Access Compliance Report

Public Rights-of-Way

(Curb Ramps)

Intersection ID: 5600	Main Street: N_TRYON_ST	Cross Street: J_M_KEYNES_DR	Location: N
ADA ID: A2F9467CF34F	Ramp Type: Perp	Initial Pass/Fail: Fail	Overall Compliance: No
Severity Score: 10			
Codes/Mitigation Info/Possible Solution		Field Measurements/Component Compliance

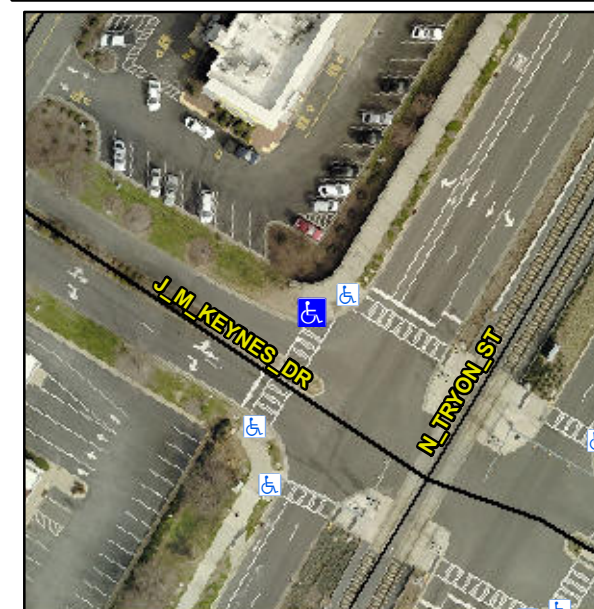
R304.5.1

Compliance	Description	Data	Compliance	Description	Data
N/A	Ramp Length (in)	72.0	Yes	Ramp Slope (%)	7.8
No	Ramp Width (in)	47.0	Yes	Ramp XSlope (%)	2.3
N/A	Flare Type LT	N/A	N/A	Flare Type RT	N/A
N/A	Flare Slope LT (%)	N/A	N/A	Flare Slope RT (%)	N/A
N/A	Flare Traversable LT?	N/A	N/A	Flare Traversable RT?	N/A
N/A	Landing Length (in)	N/A	N/A	DWS Provided?	N/A
N/A	Landing Width (in)	N/A	N/A	DWS Contrast?	N/A
N/A	Landing Slope (%)	N/A	N/A	DWS Length (in)	N/A
N/A	Landing X Slope (%)	N/A	N/A	DWS Full Width?	N/A
N/A	Landing Curb? (Y/N)	N/A	N/A	DWS Offset (in)	N/A
N/A	Shared Landing?	N/A			
N/A	Gutter Ponding?	N/A	N/A	Gutter Slope (%)	N/A
N/A	Gutter Lip Ht (in)	2.0	N/A	Gutter X Slope (%)	N/A
N/A	Painted X Walk1?	No	N/A	Painted X Walk2?	N/A
	X Walk 1 Direction	To SW		X Walk 2 Direction	N/A
N/A	X Walk 1 Width (in)	N/A	N/A	X Walk 2 Width (in)	N/A
	X Walk 1 Slope (%)	3.0		X Walk 2 Slope (%)	N/A
	X Walk 1 X Slope (%)	2.7		X Walk 2 X Slope (%)	N/A

Remove & Replace Entire Ramp.
